Memorandum

RE: MMU Comments on Independent Consultant Interim Final Draft ICAP Demand Curve Reset Report and NYISO Staff DCR Draft Recommendations

Figure 1: B-Rated Bond Yield, August 2019 to August 2020

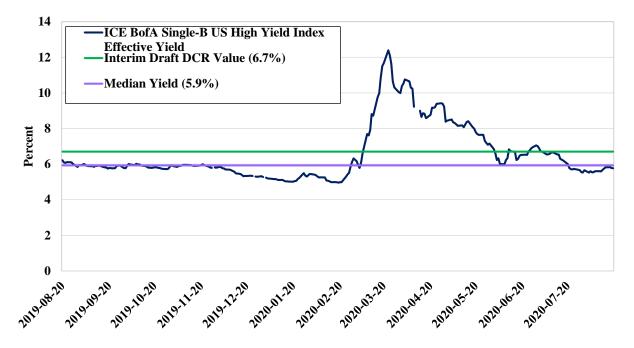
Figure 1 shows that yields began to rise sharply in late February and remained elevated in April and May. These substantial increases reflected severe liquidity issues in the credit markets that have not been sustained. When presenting their rationale for a higher cost of debt in May 2020,

the consultants pointed to the sharp increase in debt costs that occurred between March and April. In particular, the consultants highlighted costs of B-rated debt at 12.4 percent on March 23 and 9.3 percent in the week of April 21.¹ Since May, Figure 1 shows that the B-rated corporate debt benchmark has fallen considerably.² Yields then fell close to pre-COVID-19 levels in June and fell below 6 percent in August.

The purpose of this analysis is not to suggest that only the most recent yields during August 2020 should be used. Rather, it is to highlight that recent trends should provide grounds for extreme caution in considering how debt yields during a two-month period this year will relate to the cost of borrowing for the entirety of the 2021-2025 demand curve reset period. A principled approach to establishing all demand curve parameters is to seek values that reflect a reasonable expectation of the parameter over the reset period. Such an approach to calculating the cost of debt (e.g., a rule-based method such as using the median over a significant period of time) will avoid giving undue weight to short-term market fluctuations.

While the 6.7 percent cost of debt recommended by the consultants in their Interim Final Draft Report is more reasonable than the 7.7 percent draft recommendation, it is still significantly above what a historical review of benchmark rates would support. Median yields over the historical periods shown in Table 2 are consistent with our recommendation to assume a cost of debt between 6.0 and 6.5 percent. It is appropriate for the historical costs used to establish this assumption to include data since the onset of COVID-19, but not to assign it disproportionate weight to this period. In fact, given that current yields are below 6.0 percent, it would be most reasonable to assume a cost of debt at the low end of this recommended range.

Figure 2: Cost of Reserves in Draft DCR Model vs. Historical Average DA Reserve Offers

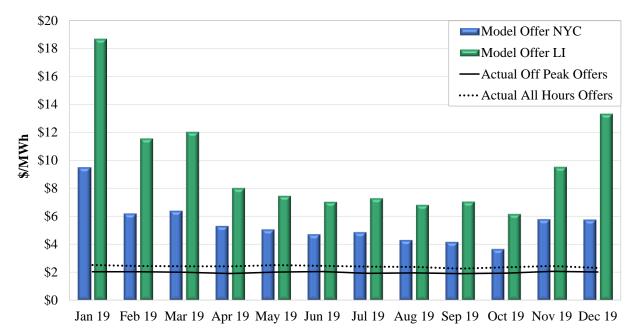
Figure 2 shows that the capacity-weighted average reserve offer was \$2.0/MWh during off-peak hours, when offers are likely to be more competitive, and \$2.4/MWh in all hours. Typical reserve offers had little variation across months. By contrast, the draft model methodology implied an average cost of \$6/MWh in Load Zone J and \$9/MWh in Load Zone K in 2019, with monthly averages as high as \$9 in Load Zone J and \$18/MWh in Load Zone K.

Based on this data, we recommended that the consultants replace the fuel-based cost of selling reserves in the day-ahead market with a constant cost of \$2.0/MWh. This will align the modeled cost with typical offer prices for similar existing units in New York. In the Interim Final Draft Report the consultants accounted for this recommendation and modified the cost of reserves for dual fuel units in their Net E&AS Model to \$2.00/MWh.

Figure 3: Historical vs. Backcast Operation for Zone C Gas-Fired Plants

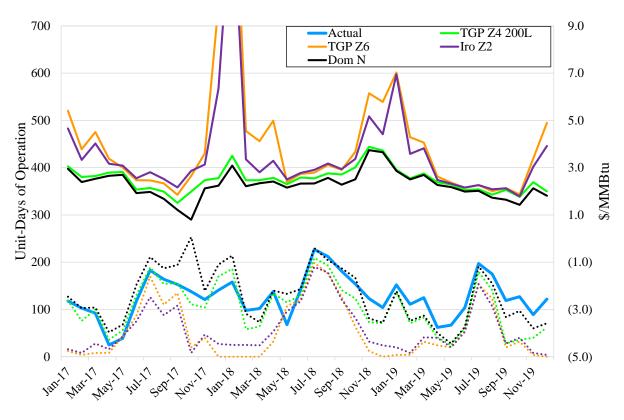
Figure 3 compares the actual number of days of historical operation for nine gas-fired units in Zone C to a backcast simulation for each unit under alternative fuel price assumptions. The simulation was performed using hourly day-ahead and real-time historical LBMPs at each plant node, daily gas indices for each hub from SNL, and plant parameters derived from unit-specific reference level data and plant-level EPA data. The lower portion of the chart (left axis) shows the actual combined days of operation compared to predicted days of operation using each gas hub price (dotted lines). The upper portion of the chart (right axis) shows average gas price for each index used in the analysis. Generator results are presented in aggregated form because confidential unit-level reference data was used for the simulation.

Of the four alternative gas hubs used, TGP Z4 200L and Dominion North were better predictors of actual Zone C plant operation than TGP Z6 and Iroquois Z2. Notably, this result holds in winter months, when prices at TGP Z6 and Iroquois Z2 often spike to high levels. During these periods, plants in Zone C operated much more often than would be expected if facing fuel costs at the TGP Z6 or Iroquois Z2 levels. Existing plants may have unique fuel supply arrangements that do not necessarily align with what the Demand Curve unit could expect to obtain.¹⁰ However, this analysis indicates that gas priced at a discount to TGP Z6 and Iroquois Z2 hubs is available in central New York, including during winter months.

Figure 5: Operational Available Capacity on TGP Segments Entering New York

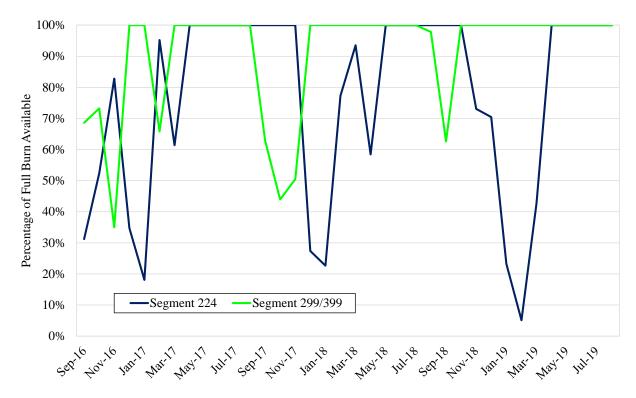
Figure 5 shows the historical average daily operational available capacity on TGP segments entering New York from Zone 4, as a percentage of the daily gas that would be required for the peaking plant to operate for 24 hours (approximately 75,000 Dth).¹² Capacity on Segment 224 connecting TGP Z4 200L to western New York was available in most months, but was frequently severely constrained in winter. Capacity on Segments 399 and 299 connecting TGP Z4 300L to central New York had greater availability. However, a review of daily critical notices issued by the TGP pipeline indicates that interruptible transport on both the 224 and 299 segments is frequently subject to restriction, particularly in winter. This data suggests that the purchase of gas at the TGP Z4 200L hub and transport to New York using interruptible service is often not possible during winter. In such months, the use of TGP Z4 200L as the gas hub may overstate net energy revenues of the peaking unit.

An alternative to offset the potential over-estimate of E&AS revenues is to use the Niagara hub in winter months. New York consistently exports gas to Canada via the Niagara interconnection between TGP and TransCanada. Hence, the price at Niagara can be seen as a proxy for the cost of acquiring gas at points in Zone A upstream of the Niagara spurline (segments 295 and 296). Data on operational available capacity indicates that segments in between zones A and C (segments 230 and 233) are rarely constrained, while segments further downstream in between zones C and F are frequently constrained in winter. Hence, the use of the Niagara price during winter months is reasonable for the region in between the bottleneck separating Zone 4 from New York and the bottleneck separating central from eastern New York.

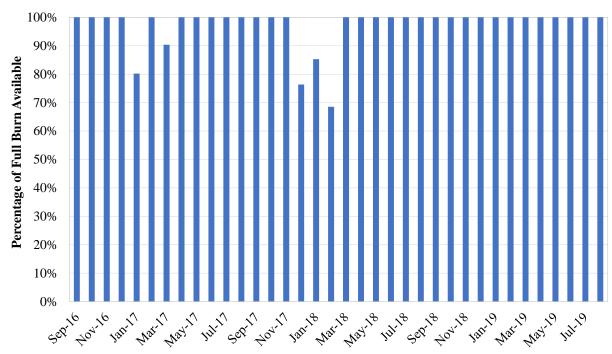
Figure 7 shows the average daily operational available capacity on the Algonquin pipeline segment passing through the Millennium Mainline station in Ramapo, NY as a percentage of the daily gas that would be required for the peaking plant to operate for 24 hours (approximately 75,000 Dth).¹⁷ Average available capacity exceeded the maximum daily burn in most months, and covered a high percentage of maximum daily burn even in cold winter months. This is likely a conservative measure, as a peaking unit typically will not generate for all hours of a day. Furthermore, as noted above, the recommended peaking plant design for Rockland County is dual fuel and, therefore, also has the option to run on oil in the minority of days when gas may not be available.

Hence, we consider the consultants' use of TETCO M3 plus \$0.27/MMBtu (along with the assumed intraday premium or discount of 10 percent) to be appropriate for the Rockland County unit, while use of the Algonquin Citygate or Iroquois Zone 2 hubs would be inappropriate given the county's proximity to the TETCO M3 market zone.
